SOUTHWEST INTERTIE PROJECT

FINAL ENVIRONMENTAL IMPACT STATEMENT and PROPOSED PLAN AMENDMENT

July 1993

COVER SHEET
Southwest Intertie Project
Final Environmental Impact Statement/Proposed Plan Amendment

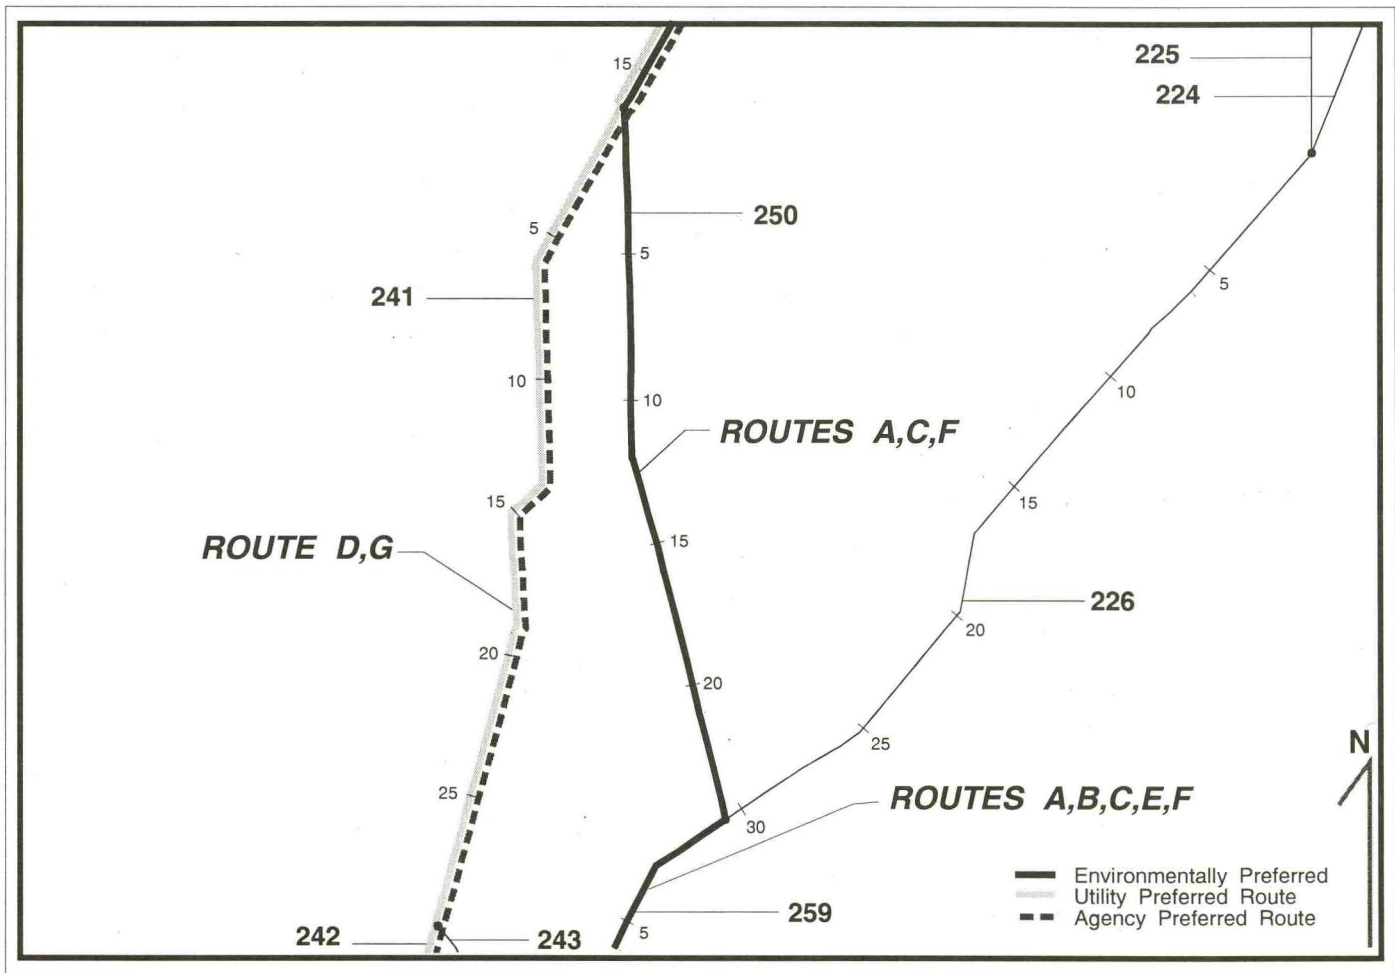
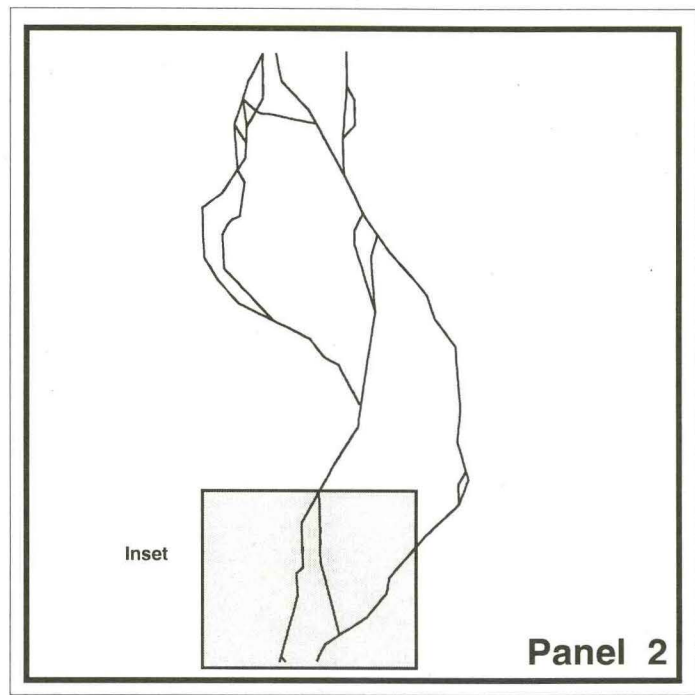
- Panel 2 - Alternative Routes Map:** Route D was incorrectly labeled on this map. The map shows Route D following Links 250, 259, and 260. Route D should actually follow Links 241, 243, and 245. Figure 4-1 indicates the corrected labeling of the alternative routes.

CORRECTIONS TO: Panel 3 - Alternative Routes

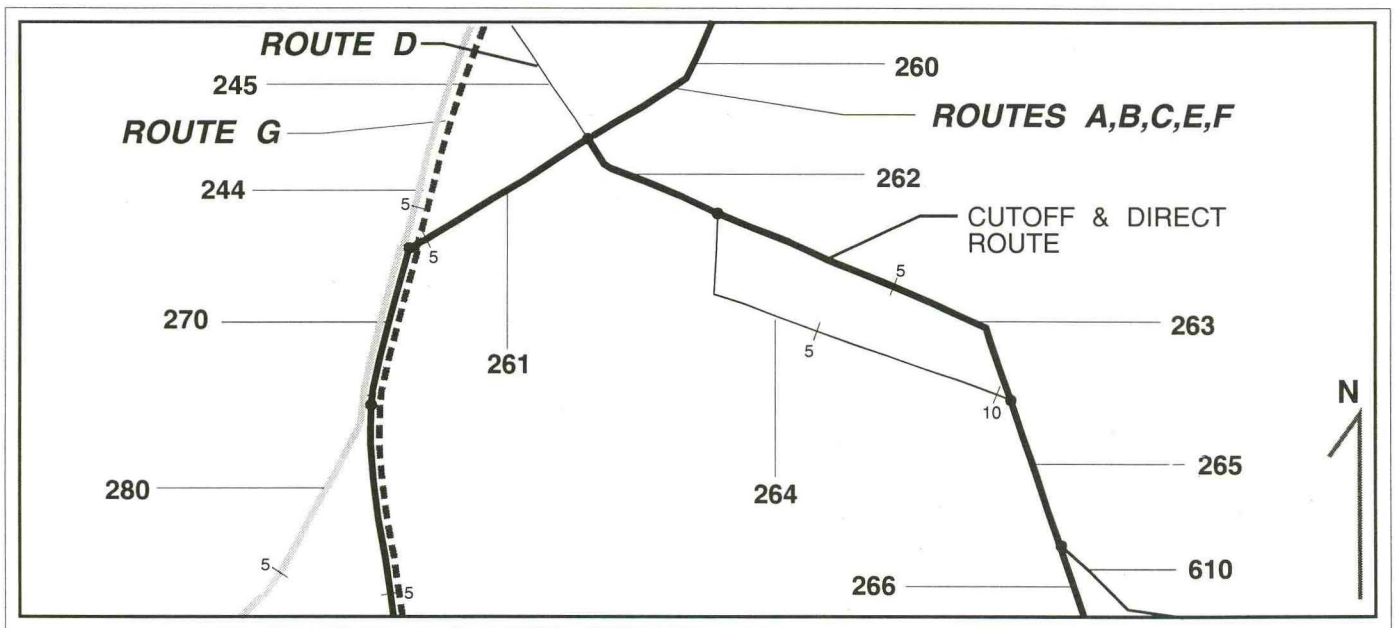
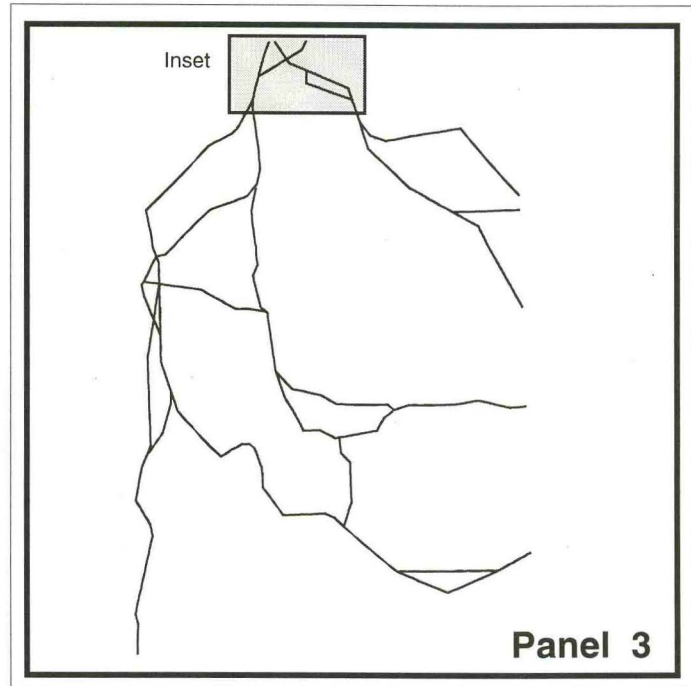
- Panel 3 - Alternative Routes Map:** Route D was incorrectly labeled on this map. The map shows Route D following Links 250, 259, and 260. Route D should actually follow Links 241, 243, and 245. Figure 4-2 indicates the corrected labeling of the alternative routes.

The labels for Route D were incorrect on this map. The correct labeling for the Route D is illustrated below.

CORRECTIONS TO: Panel 4 - Alternative Routes

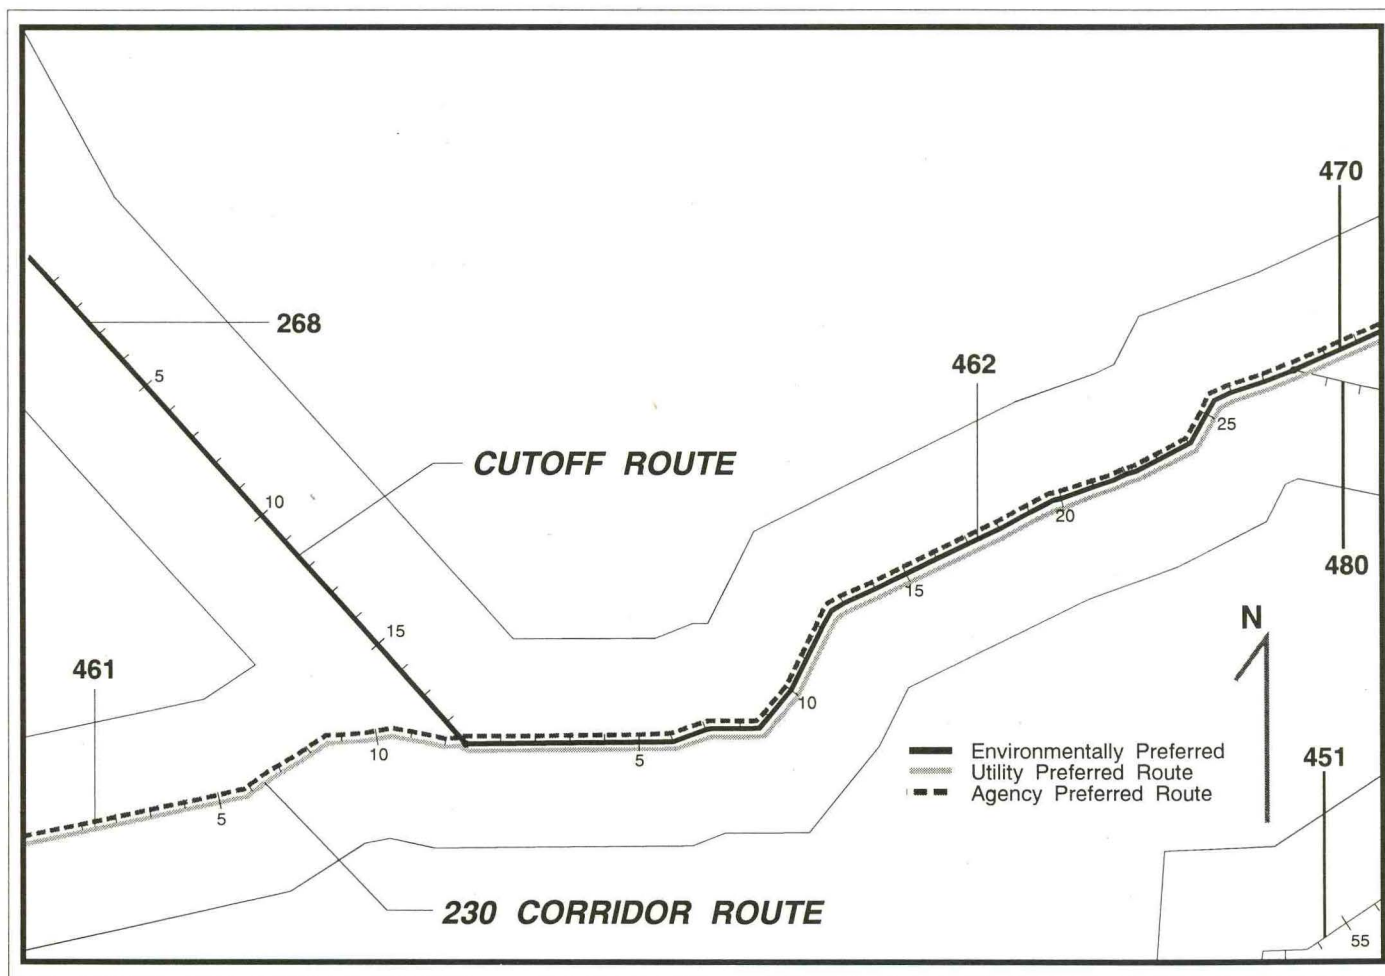
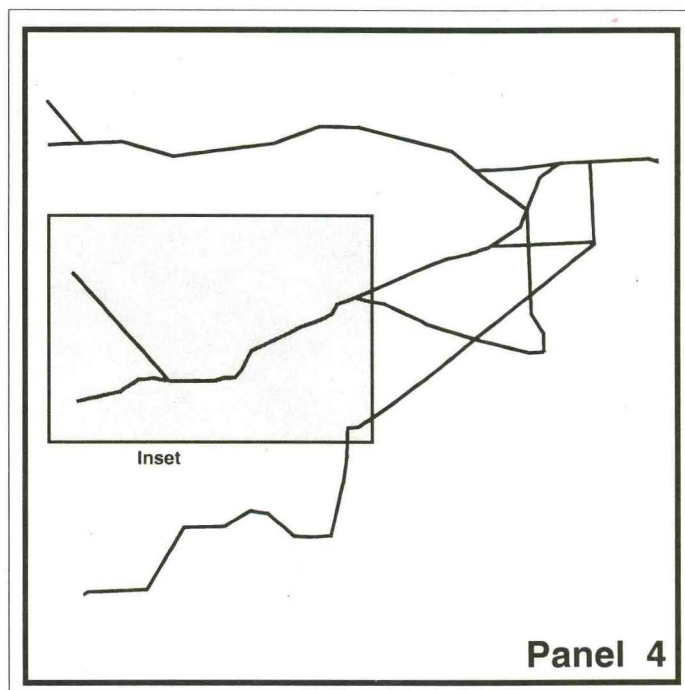
- Panel 4 - Alternative Routes Map:** The labels for the "230kV Corridor Route" and "Cutoff Route" are transposed on this map. Figure 4-3 indicates the corrected labeling of these alternative routes.

The labels for "230 kV Corridor Route" and "Cutoff Route" were transposed on this map. The correct labeling is illustrated below.

CORRECTIONS TO: Panel 2 - Land Use Resources

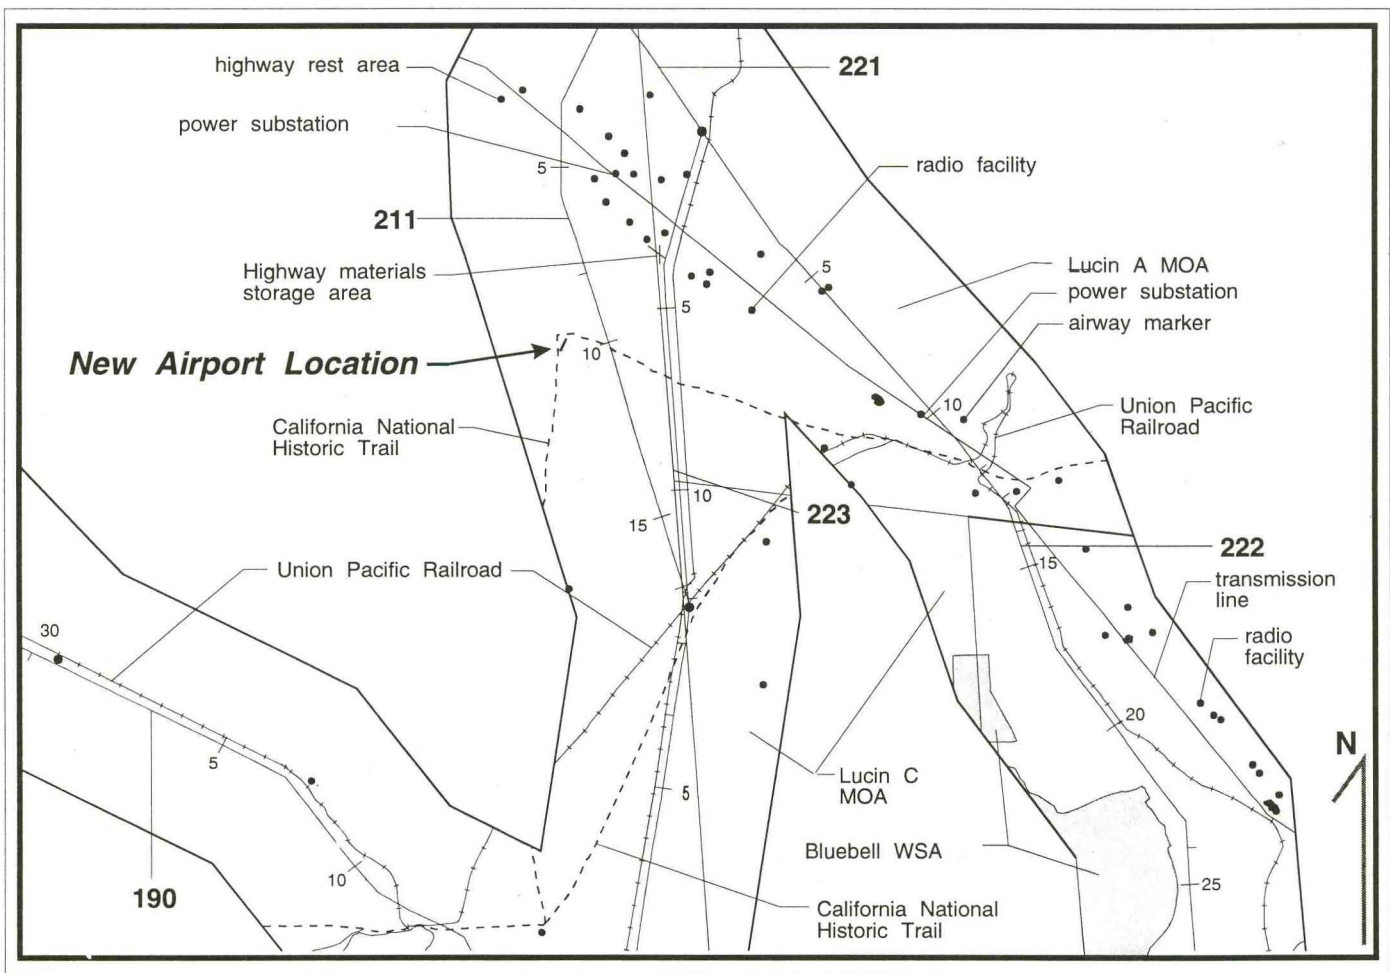
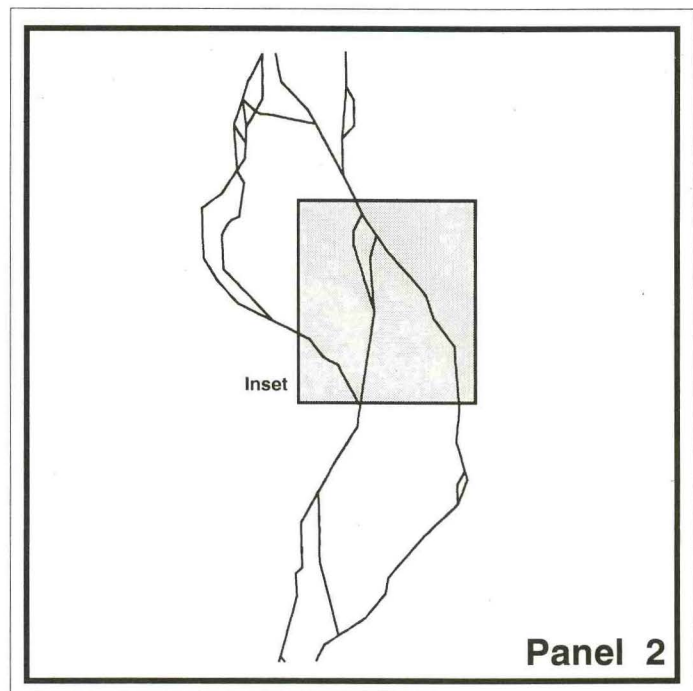
- Panel 2 - Land Use Resources:** The Big Springs Ranch private grass airstrip is missing from this map. Figure 4-4 indicates the location of the airstrip.

A private grass airstrip near Big Springs Ranch was not shown on this map. Its location is illustrated below.

CORRECTIONS TO: Panel 3 - Land Use Resources

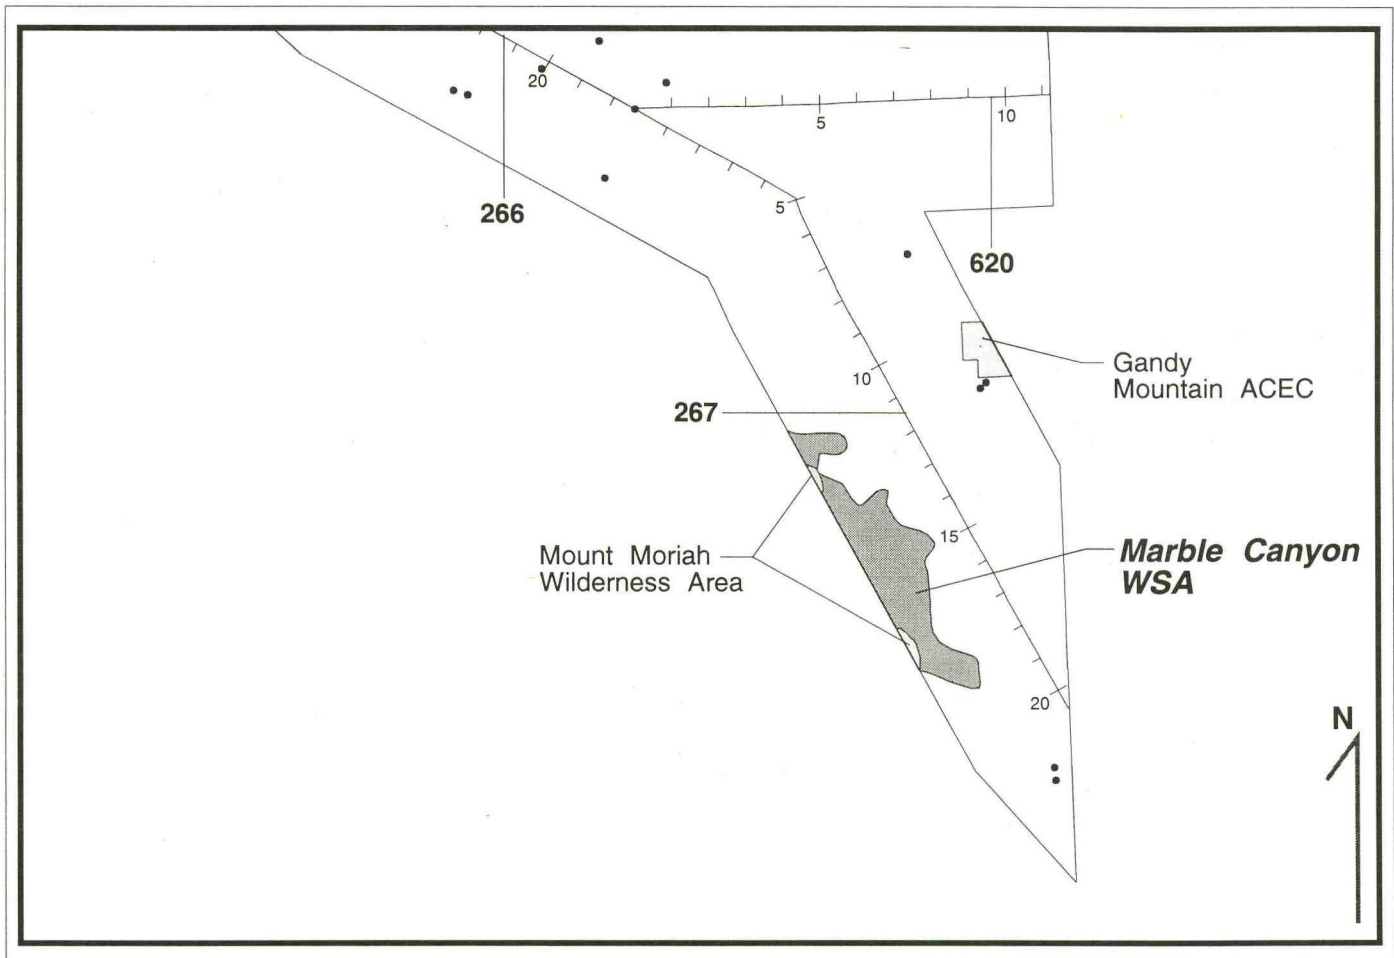
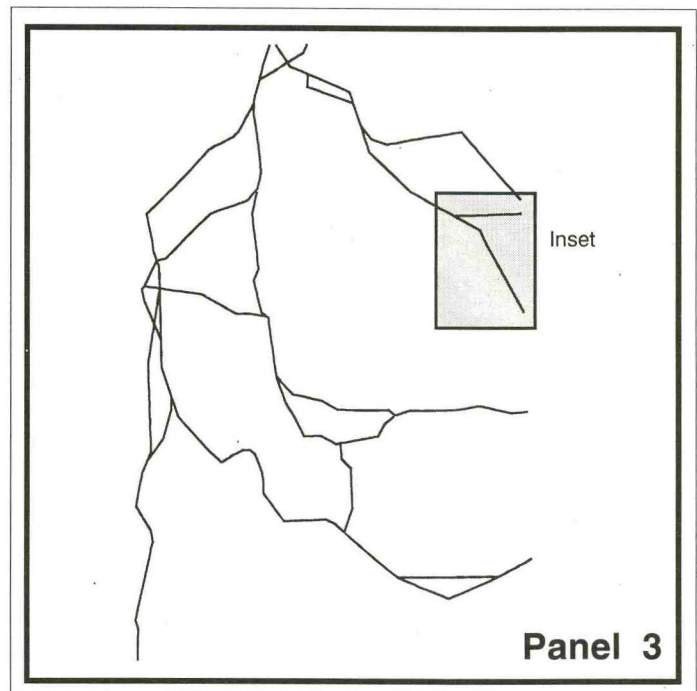
- Panel 3 - Land Use Resources:** Marble Canyon WSA is not shown on this map. It is located on Link 267 and illustrated in Figure 4-5.
- Panel 3 - Land Cover:** Between miles 15 and 20 on Link 267, portions identified as playa are labeled incorrectly. The correct identification is sage scrub.

Marble Canyon WSA was not shown on this map. The boundary for this area is illustrated below.

CORRECTIONS TO: Panel 4 - Land Use Resources

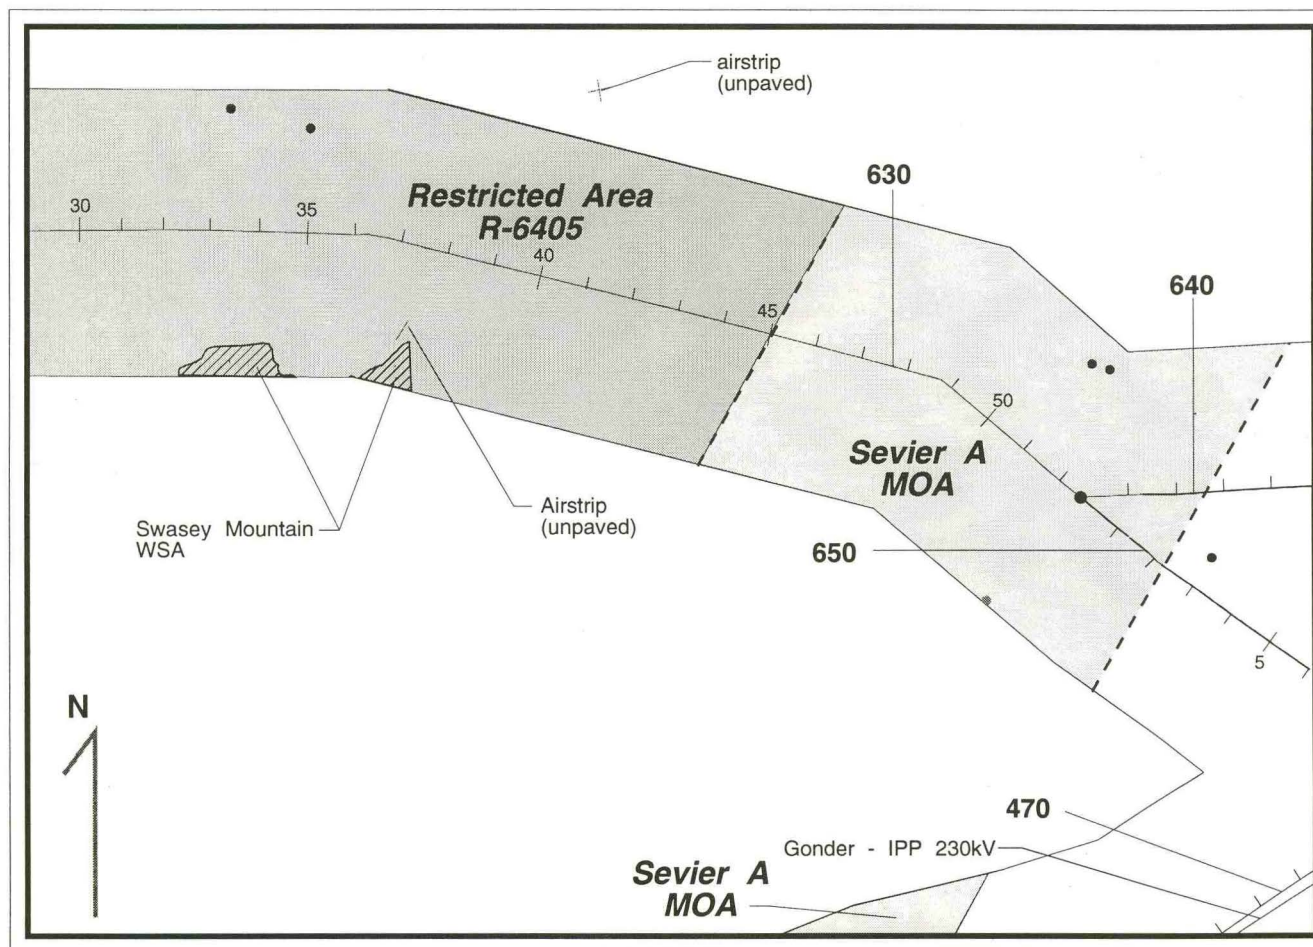
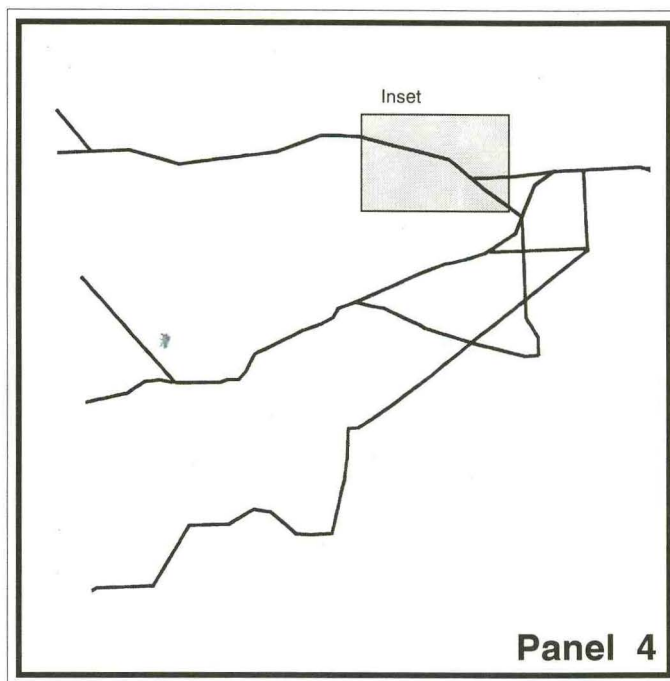
The Restricted Area R-6405 was mapped incorrectly on the Panel 4 - Land Use Resources Map. It is illustrated in the below diagram.
